UNITED STATES PATENT AND TRADEMARK OFFICE

APPLICATION NO.	FILING DATE	FIRST NAMED INVENTOR	ATTORNEY DOCKET NO.	CONFIRMATION NO.
10/596,843	06/27/2006	Hideo Tanaka	JP030025	1240
24737	7590	11/20/2009		
PHILIPS INTELLECTUAL PROPERTY & STANDARDS P.O. BOX 3001 BRIARCLIFF MANOR, NY 10510			EXAMINER CHIEN, LUCY P	
			ART UNIT 2871	PAPER NUMBER
			MAIL DATE 11/20/2009	DELIVERY MODE PAPER

Office Action Summary	Application No. 10/596,843	Applicant(s) TANAKA, HIDEO	
	Examiner LUCY P. CHIEN	Art Unit 2871

DETAILED ACTION

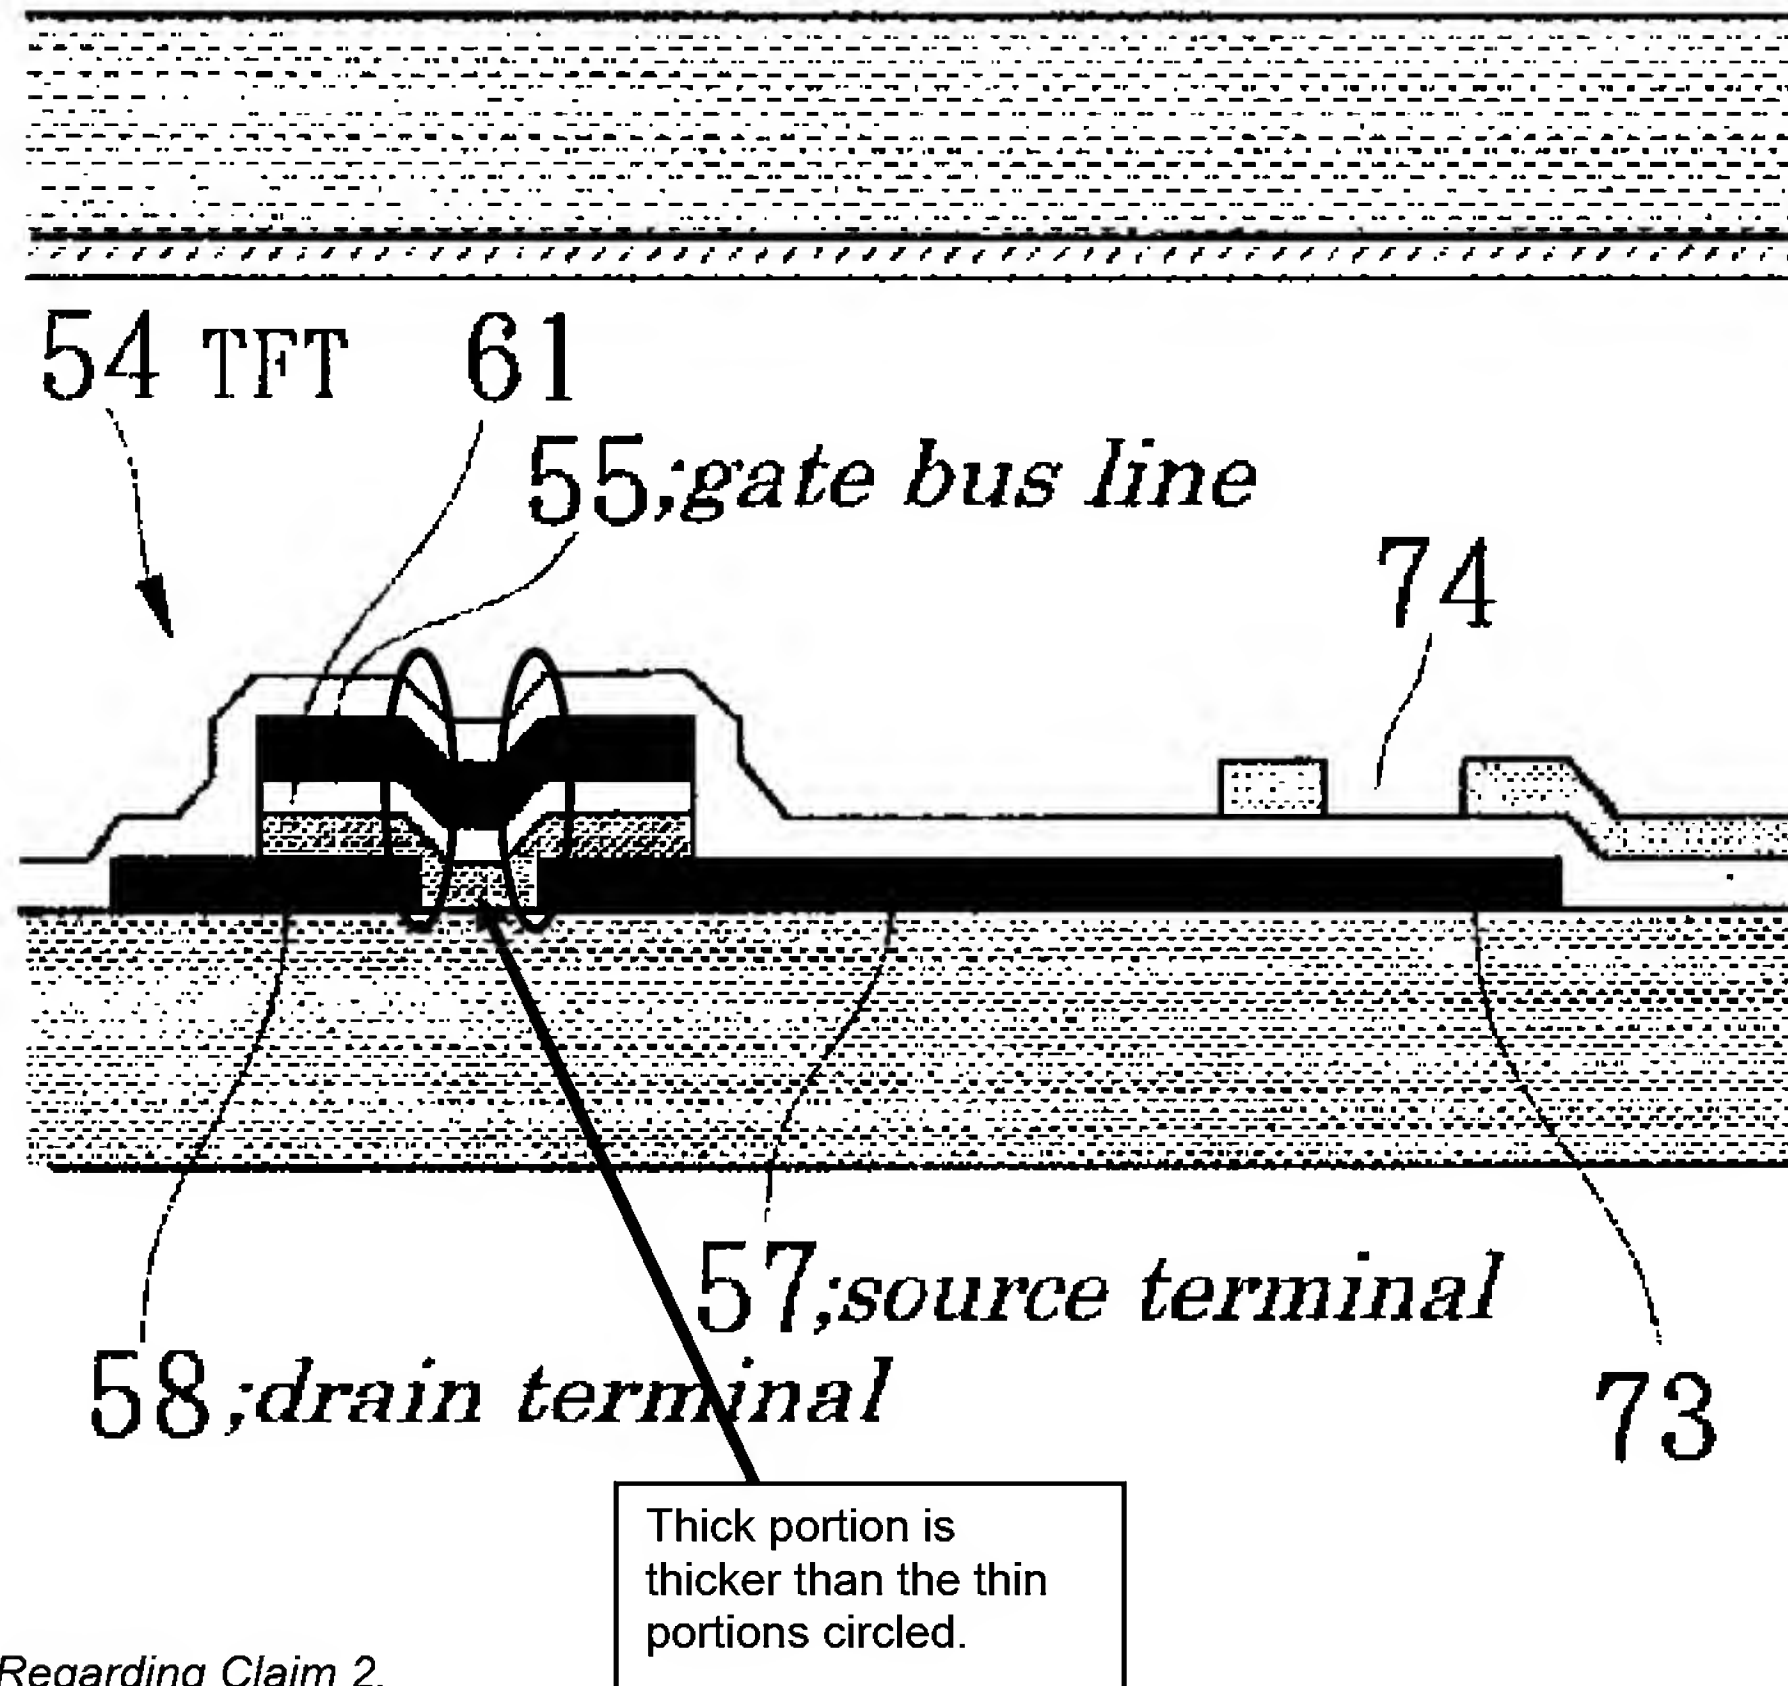
Suzuki et al discloses (Fig. 17, Fig. 18) a source electrode (57) and a drain electrode (58) formed on an insulating substrate (11) a gate insulating film (61) having a relatively thin film portion (circled below) partially on said source electrode (57) and said drain electrode (58) and a relatively thick film portion (with respect to the thin portions circled below) between said source electrode and said drain electrode (shown below); and a gate bus layer (55) formed on said gate insulating film (61) including at least said thin film portion, wherein an MIM (Column 29, rows 50-56) structure is configured by

said source electrode, said drain electrode, said gate insulating film in said thin film portion and said gate bus layer.

Suzuki et al does not disclose an interlayer insulating film between the substrate and the source and drain electrode.

In addition to Suzuki et al and Inoue et al as disclosed above, Suzuki discloses wherein a plurality of said MIM structures are connected in series. (see Fig. 17, TFT 54 can be replaced with a MIM, The other TFT/MIM is located at the top, diagonally above the labeled number 56).
